BIDS AND AWARDS COMMITTEE
National Dairy Authority – South Luzon Department

REF: SUPPLY, DELIVERY, INSTALLATION AND COMMISSIONING OF MILK PROCESSING EQUIPMENT FOR SOUTH LUZON AREA (ORIENTAL MINDORO AND QUEZON PROVINCE) (PB#21-003)

Bulletin No. 1
2 August 2021

The proposed layout of the processing facility is illustrated below:

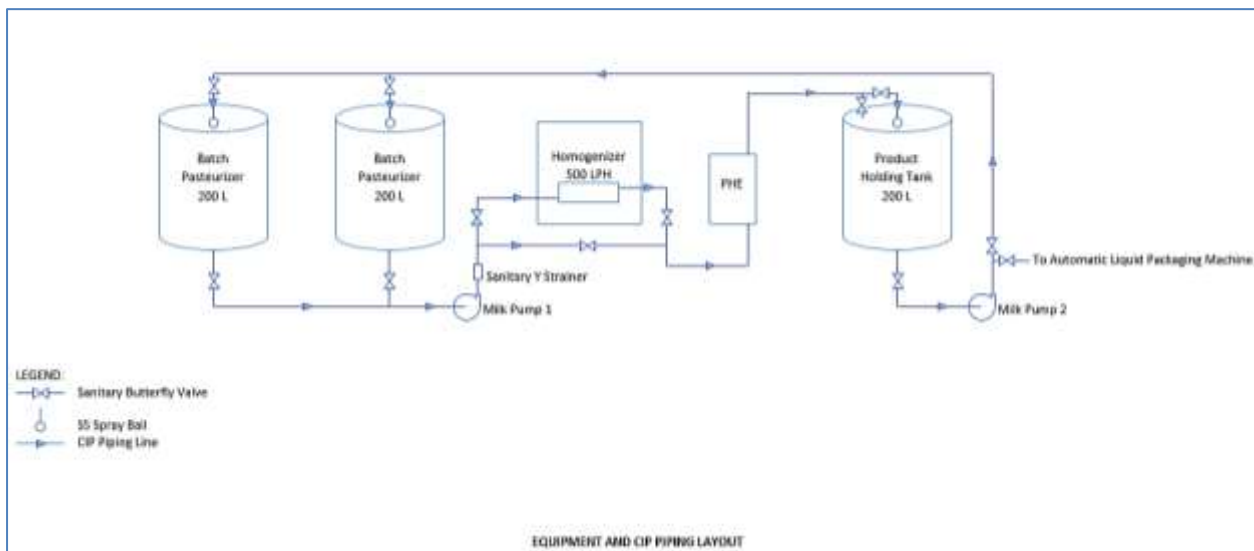
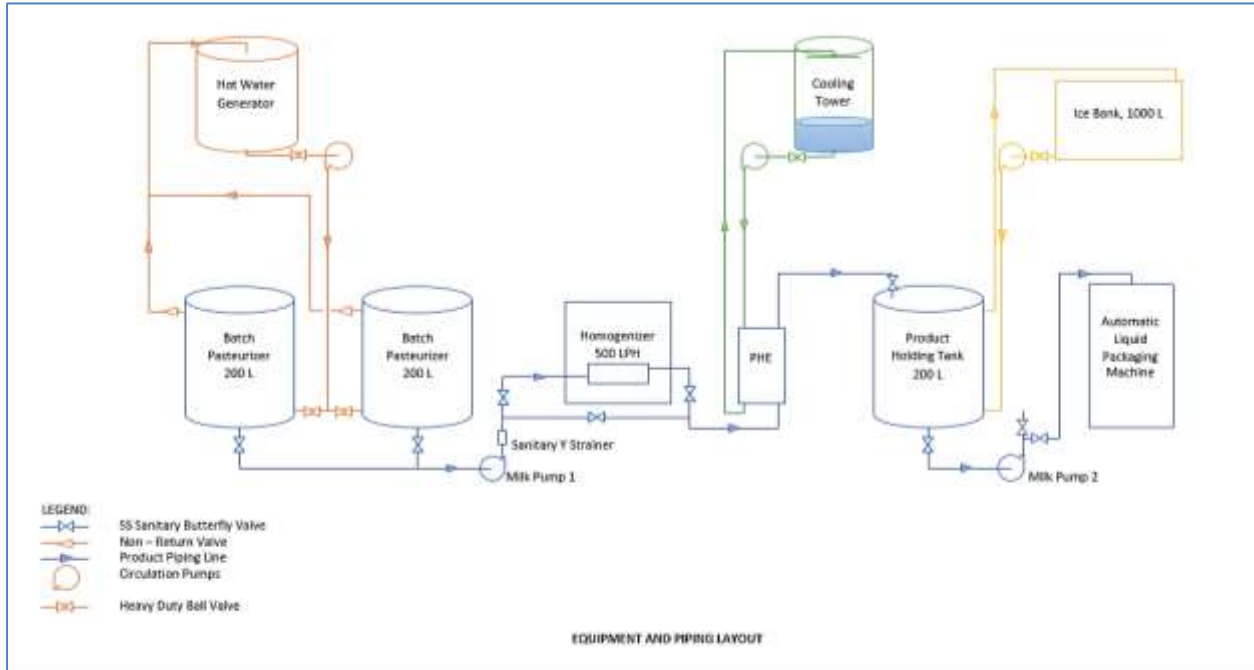
Milk pump not included.
